Response to Comments
Application No.TPB/A/SK-CWBS/52

PROJECT TITLE
Section 16 Planning Application for Utility Installation for Private Project (Underground Cable Water, Telecommunication and Other Utilities Ducting) and associated excavation of land and filling of land at Various Lots in DD 233, Clear Water Bay, Sai Kung, N.T., New Territories

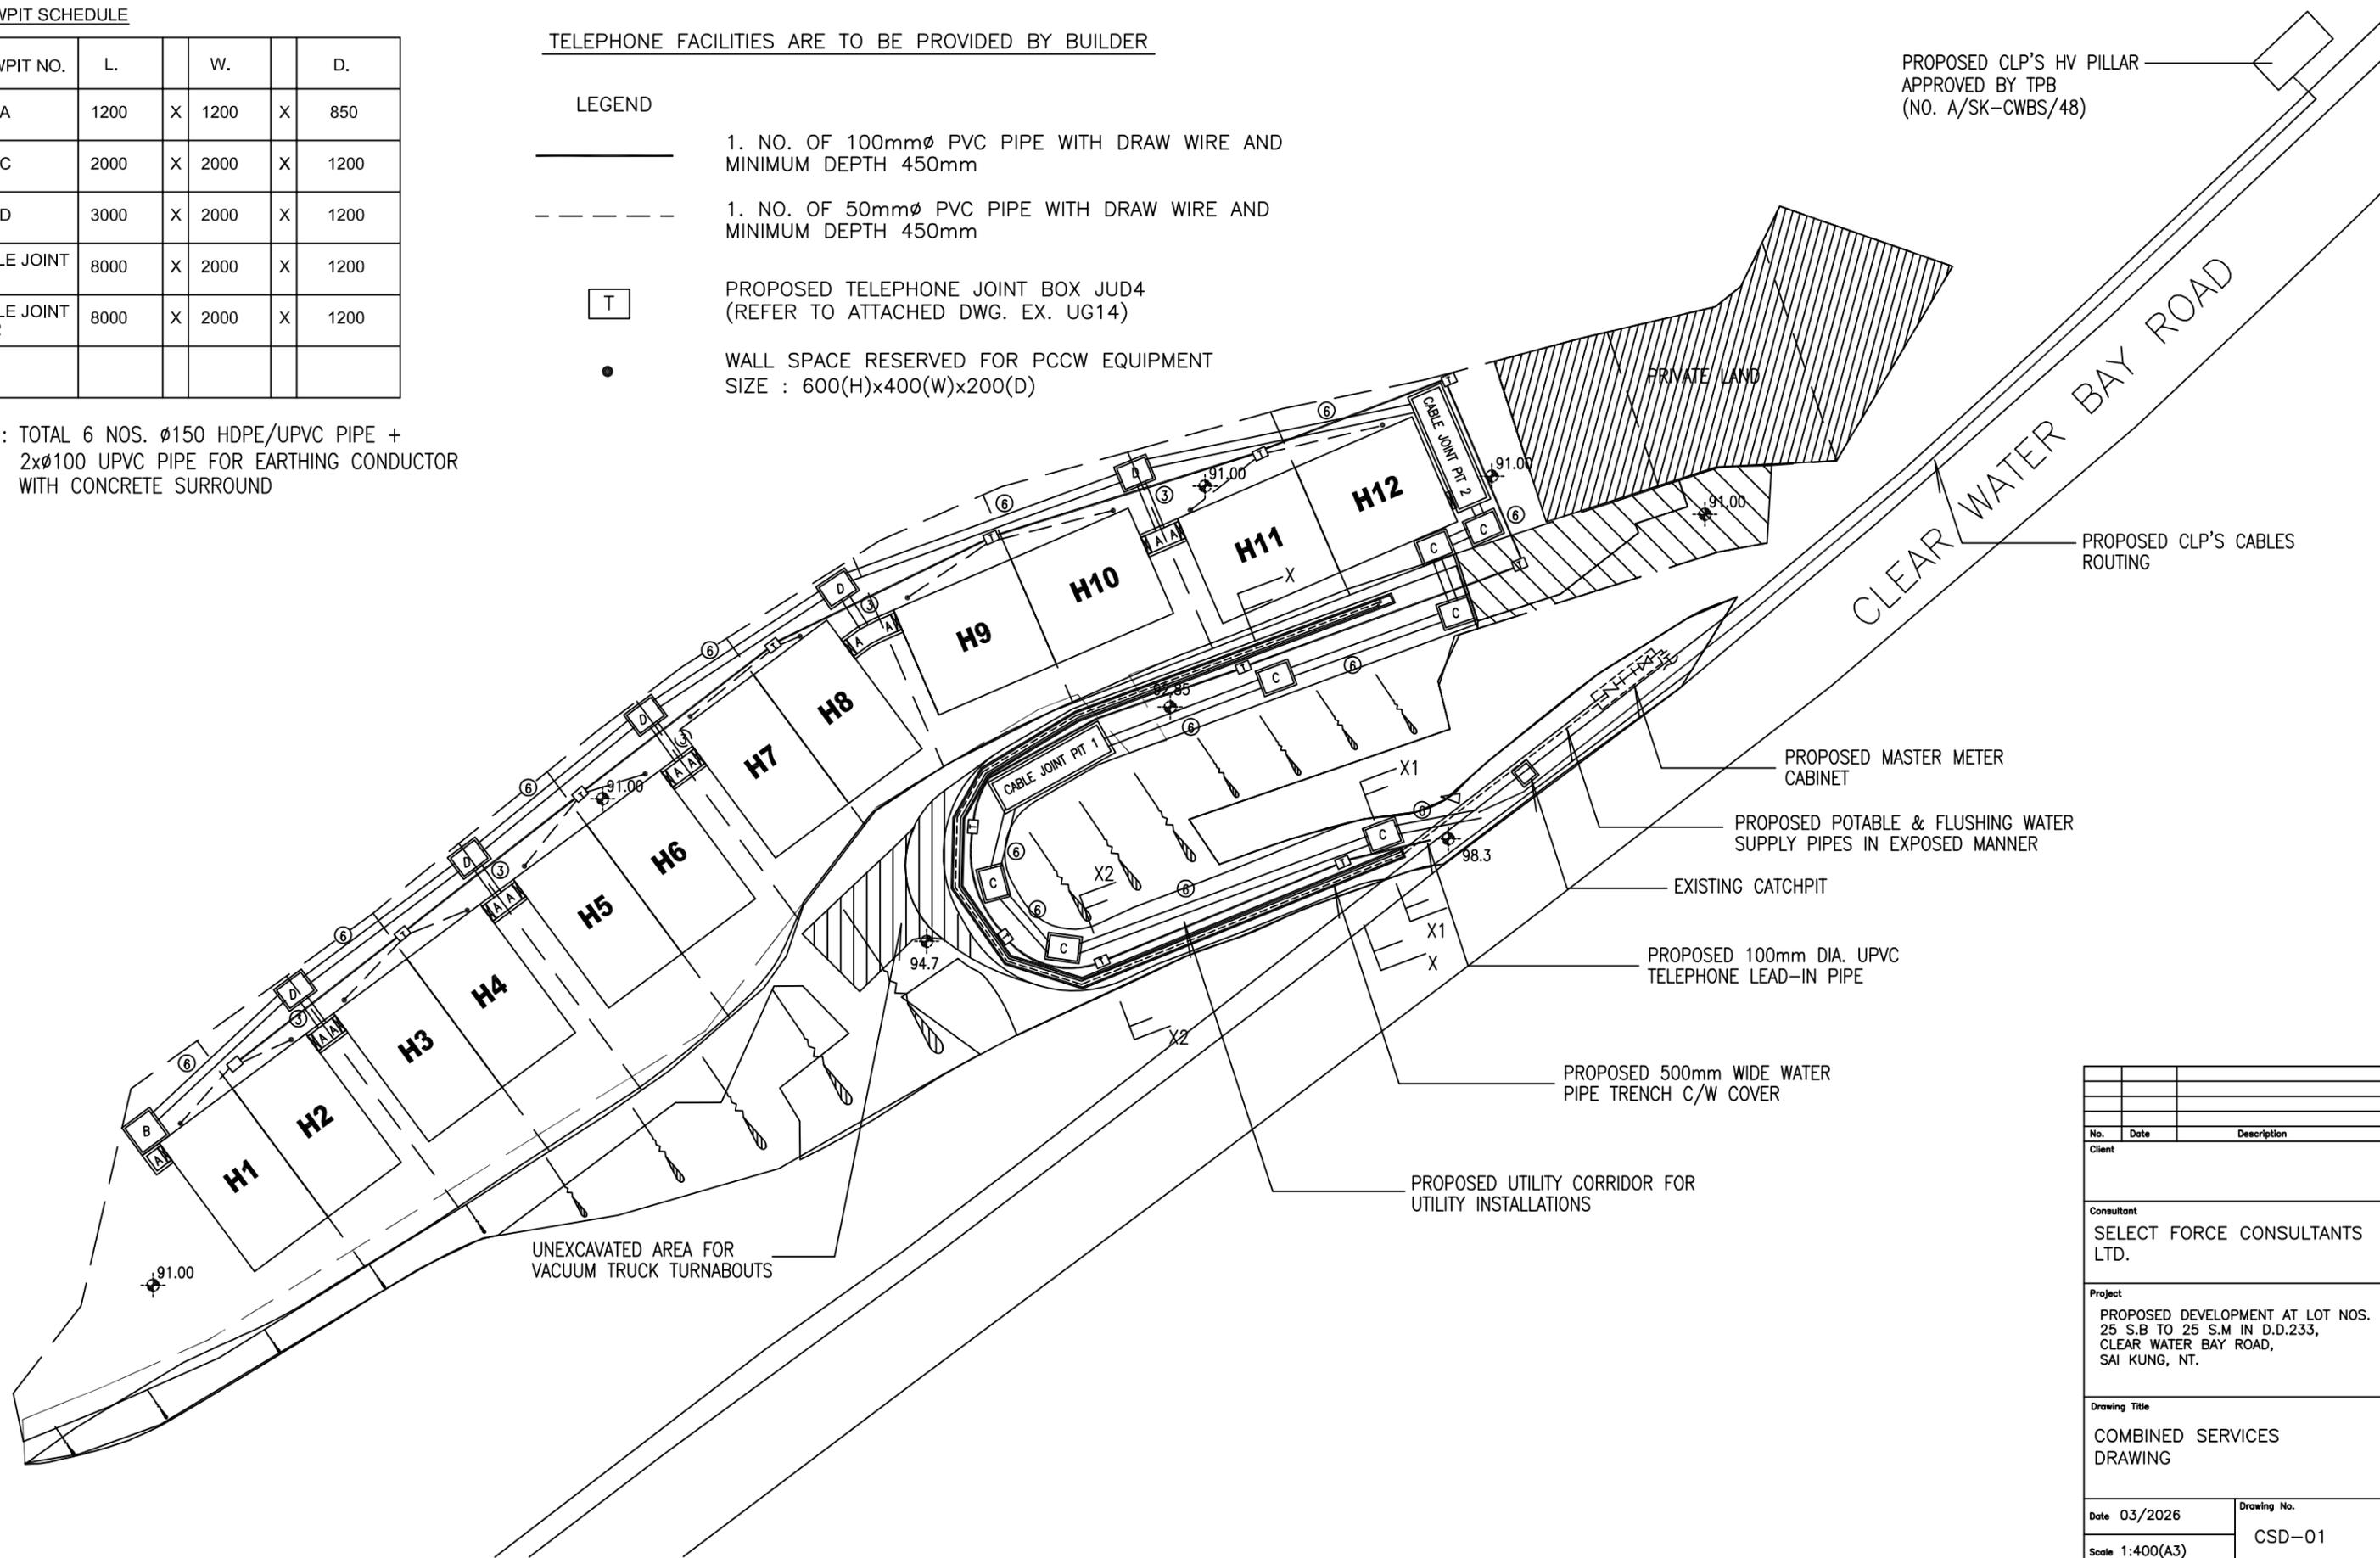
iv	<p>according to the planning statement, the proposed utility installations involve underground cable, water, telecommunication and other utilities ducting. However, the revised Section Plan only shows "中電井" and "水喉坑". Please clarify and provide alignments and dimensions of other proposed utilities, if any.</p>	<p>The alignments and dimensions of the proposed utility installations are shown on the attached combined services drawings (dwg. CSD-01A and CSD-02).</p>

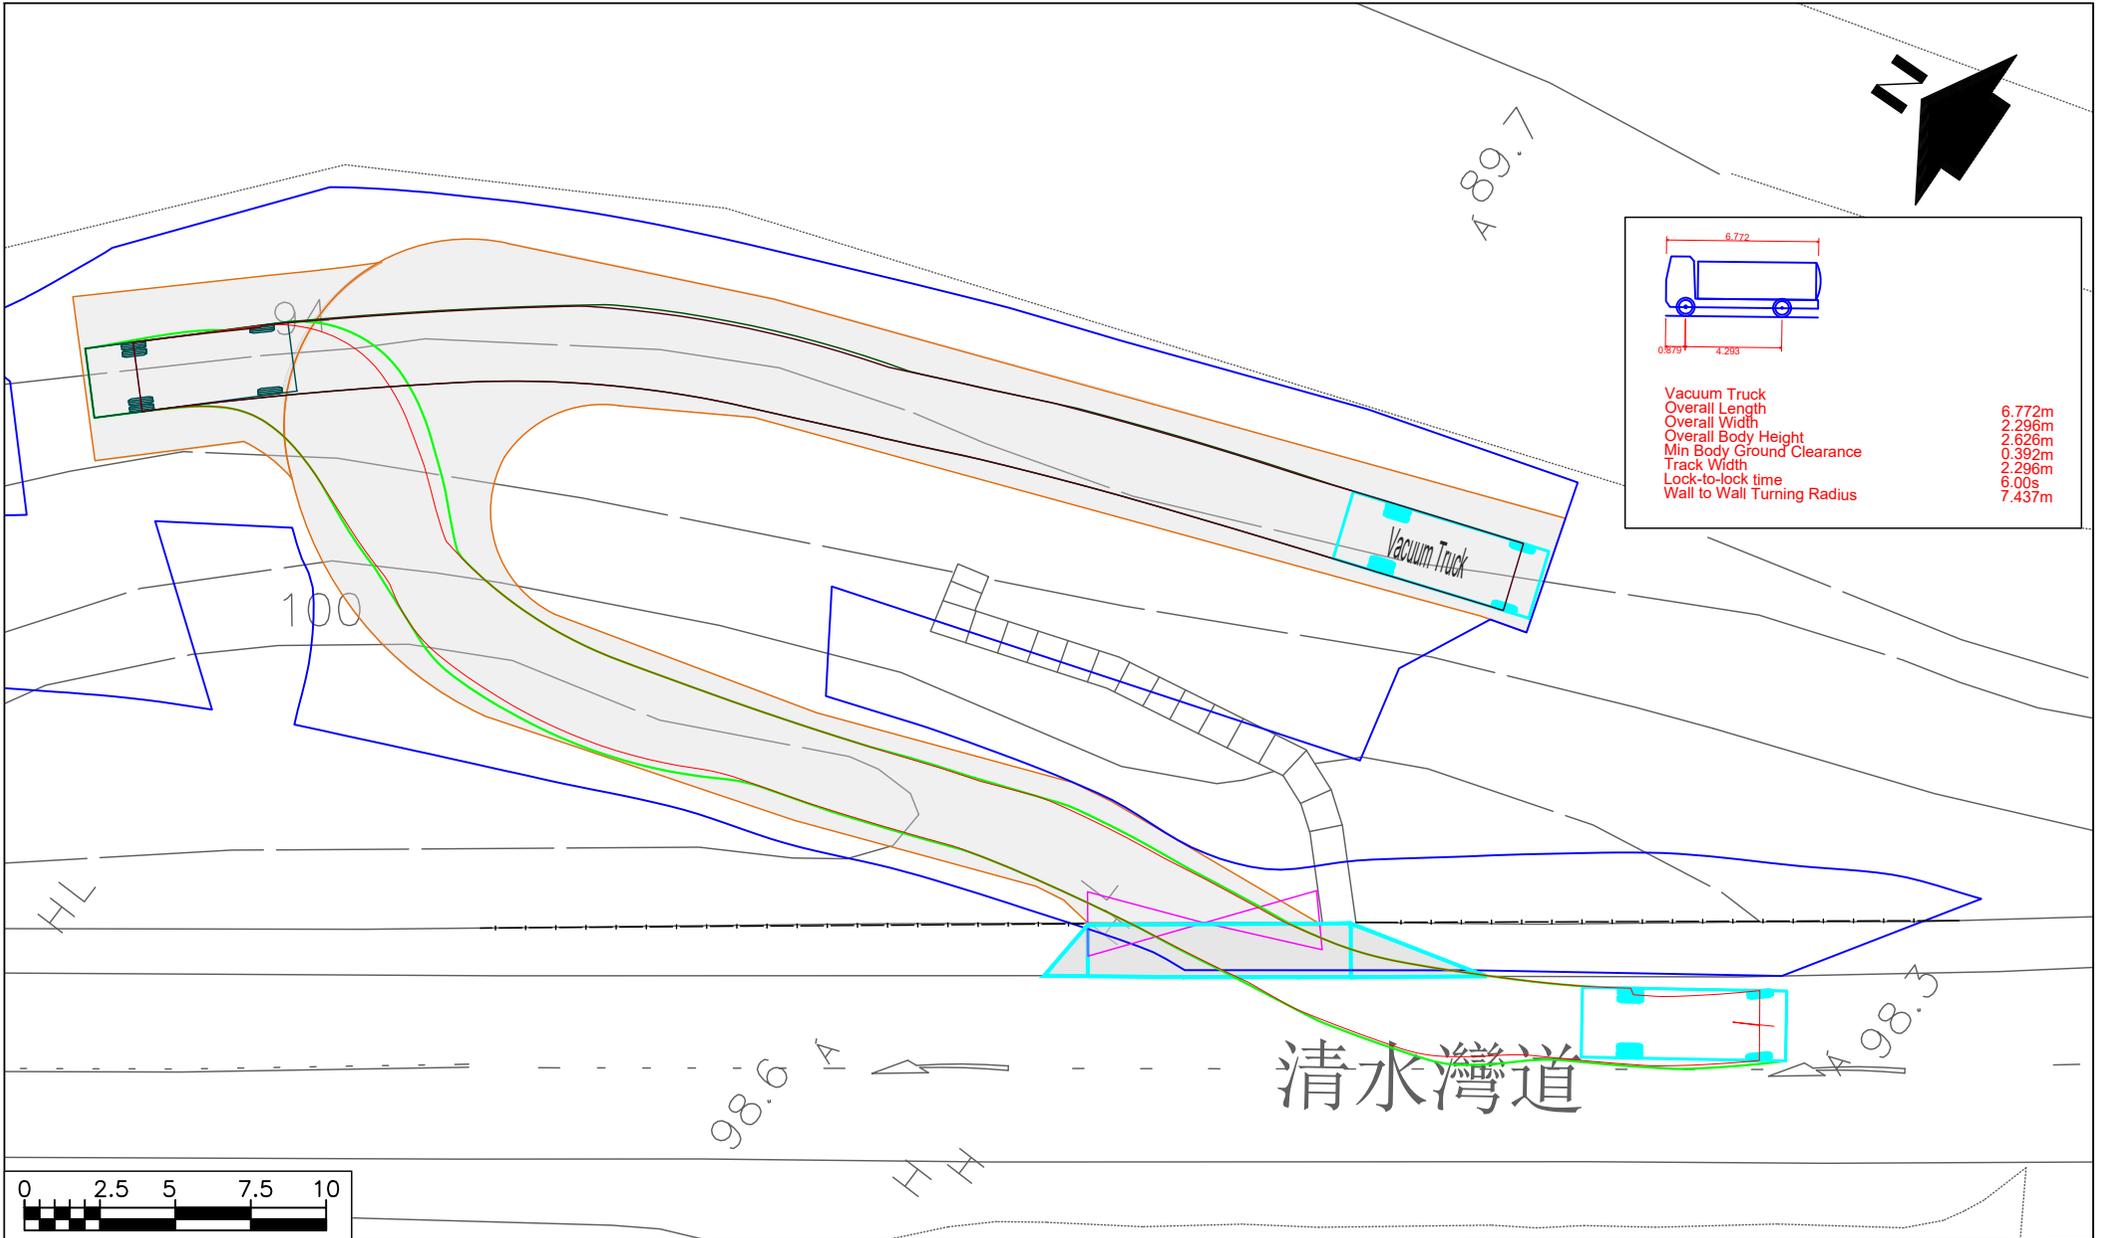
h	it is stated in the Planning Statement that the utility corridor would also provide vehicular access for vacuum trucks. Please clarify whether the vehicular access is only for the vacuum trucks, and advise relevant management measures to implement the access control; and	Vehicular access is limited to maintenance truck such as vacuum trucks for septic tank maintenance or utilities maintenance vehicular such as power cable wiring, telecom wiring and plumbing pipe maintenance. The traffic frequency of respective utilities is typically at annually or every 6 months. The management measures is stated in item D of this RtC.
i	Please provide the scale of the drawings submitted.	The drawings with the scale are attached at Appendix 2 for your review and approval.
Highways Department (Chief Highway Engineer/New Territories East)		Mr. Viggo CHAN Tel: [REDACTED]
Comments		Response
1	Regarding the proposed run-in/out, please advise the land status of the proposed vehicular access;	The proposed run-in/out is situated primarily within the applicant's private lot (Lot 28RP in DD 233), held under a Block Government Lease, with a small portion extending onto the existing pavement. To ensure its full functional integrity, the applicant will undertake the maintenance and management responsibility of the entire proposed run in/out.

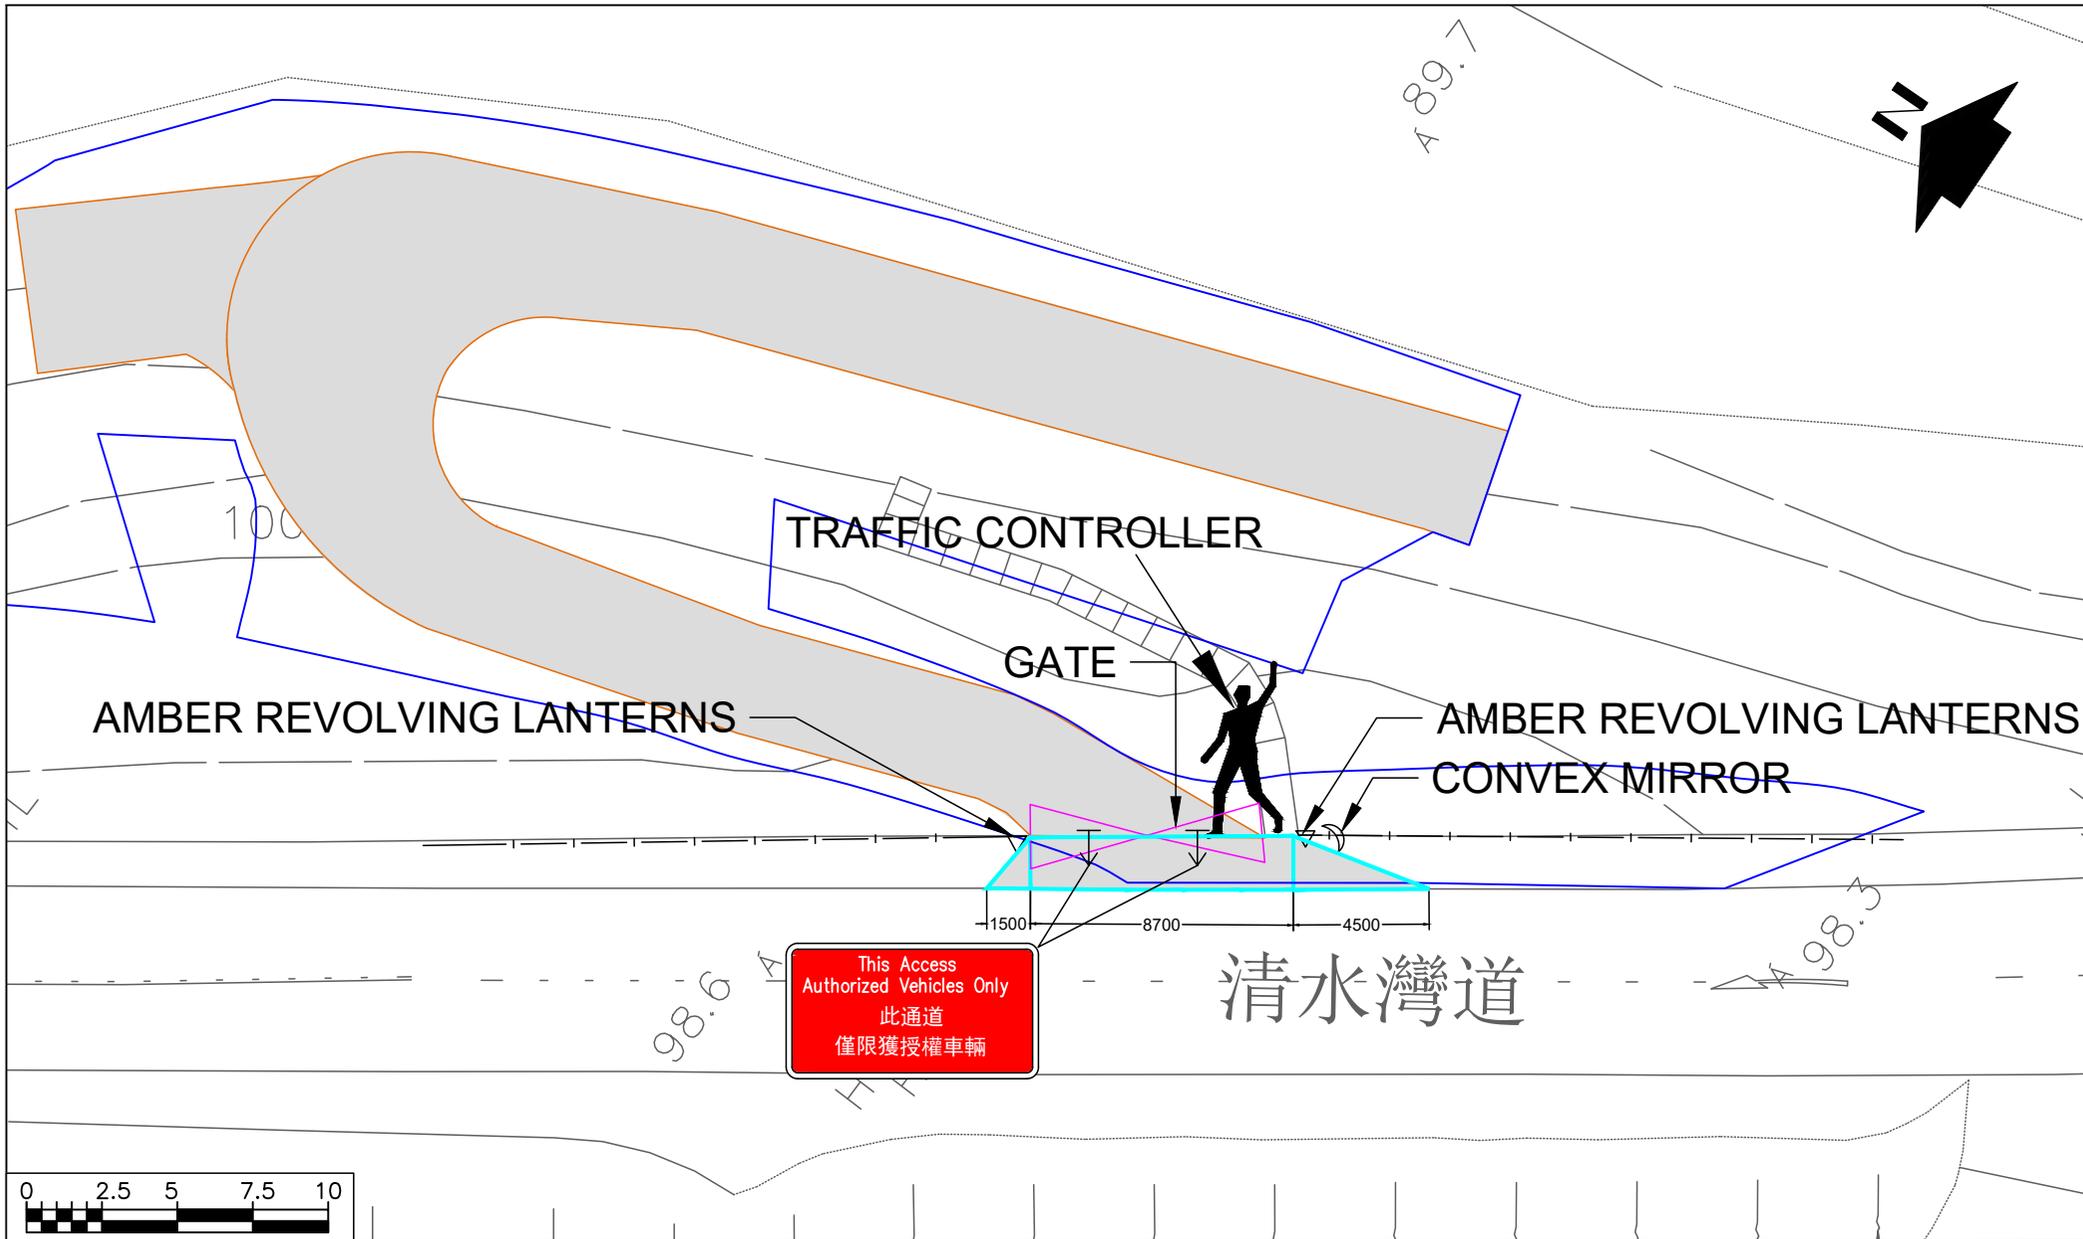
g	<p>it is noted there is level difference between Clear Water Bay Road and the application site, please advise if barrier would be provided for the safety of vehicles;</p>	<p>The tubular railings are proposed to install at the footpath (Please refer to FIGURE 3A at Appendix 2) and the highways standard drawing no.: H4103B (a copy is shown at Appendix 2).</p>

4	a notable level difference between Clear Water Bay Road and the subject site is noted. Please advise whether any physical measures (e.g barrier) would be provided to safeguard the road users. Please seek TD's advice and agreement from traffic engineering point of view. engineering point of view.	The tubular railings are proposed to install at the footpath (Please refer to FIGURE 3A at Appendix 2) and the highways standard drawing no.: H4103B (a copy is shown at Appendix 2) .
---	--	---
